Bayside Planning Panel

Item No	5.6
Application Type	Section 96(2) Application – Modification to Residential Flat Building
Application Number	DA-15/253/02
Lodgement Date	12 December 2016
Property	37A-39 Daphne Street, BotanyLot 202 DP 1001451 and Lot 6 Sect E DP 1787
Owner	TMR Investments Group P/L
Applicant	TMR Investments Group P/L
Proposal	Section 96(2) to modify Development Consent No. 15/253 to amend the basement car park, approved units and an addition of 3 (2 x 1 bed and 1 x 2 bed) units on a new upper level along with a modified communal open space area. The proposal now includes 21 units with 10 affordable units.
No. of Submissions	Seven (Round 1) Nil (Round 2) Nil (Round 3)
Cost of Development	N/A
Report by	Angela Lazaridis- Senior Development Assessment Officer

Planning Assessment Report

Application Number:	DA/15/253/02
Date of Receipt:	12 December 2016
Property:	37A-39 Daphne Street, Botany Lot 202 DP 1001451 and Lot 6 Sect E DP 1787
Owner:	TMR Investments Group P/L
Applicant:	TMR Investments Group P/L
Proposal:	Section 96(2) to modify Development Consent No. 15/253 to amend the basement car park, approved units and an addition of 3 (2 x 1 bed and 1 x 2 bed) units on

Figure 1. Amended Site Plan

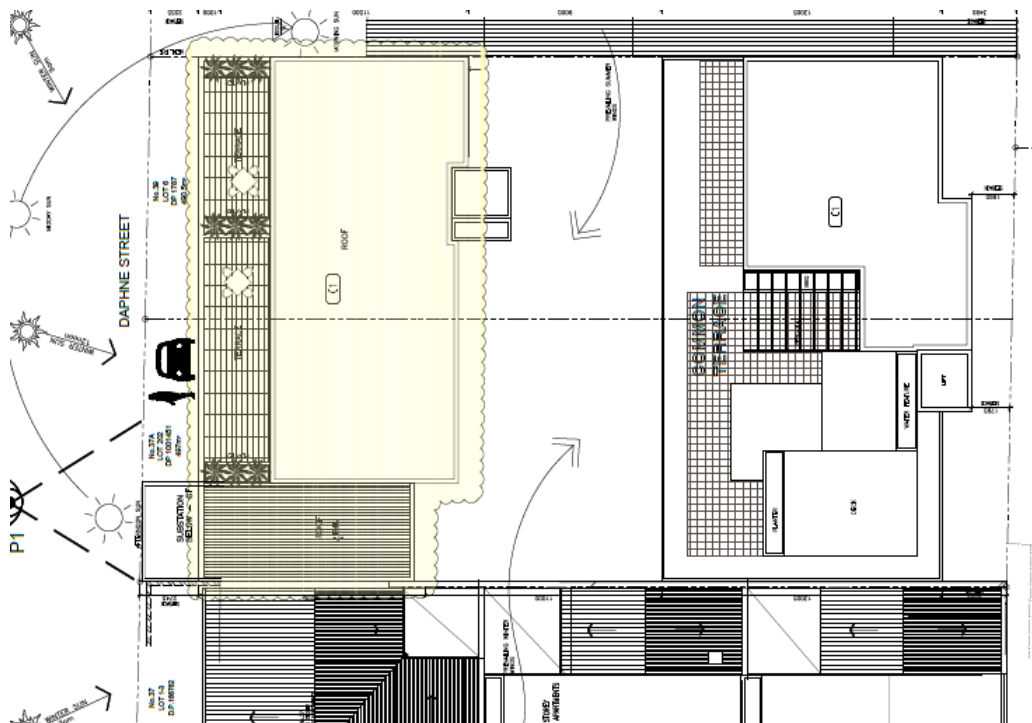
The below figures demonstrate the modifications proposed as part of this application:

Figure 12. Approved third level with communal open space on southern building

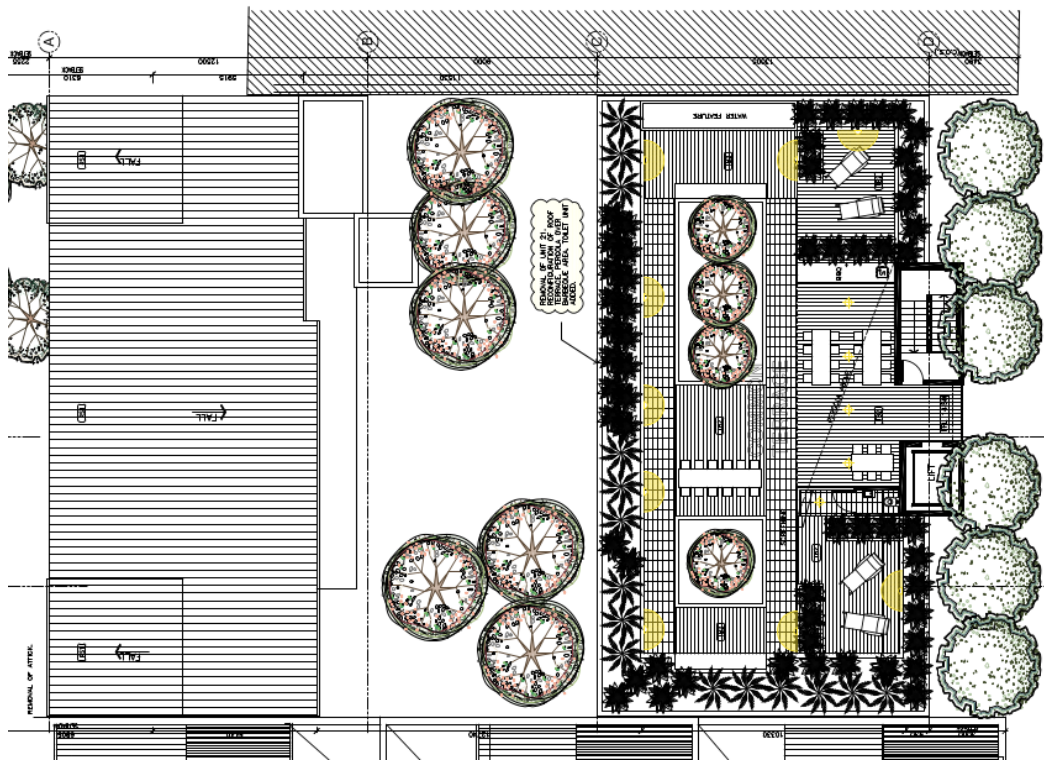
The location of Unit 21 reduces the approved communal open space area that was originally approved (Figure 12 above). The approved communal space on the rooftop was 310sqm and the proposed communal open space is 194.37sqm. While there is a reduction in communal open space on the rooftop, the area is still compliant with the minimum communal open space requirement of 25% of the site area (246.88sqm) as the ground floor approved

communal open space is 181sqm. This means that there is a total of 375.37sqm or 38%. Therefore, the proposed modification is supported.
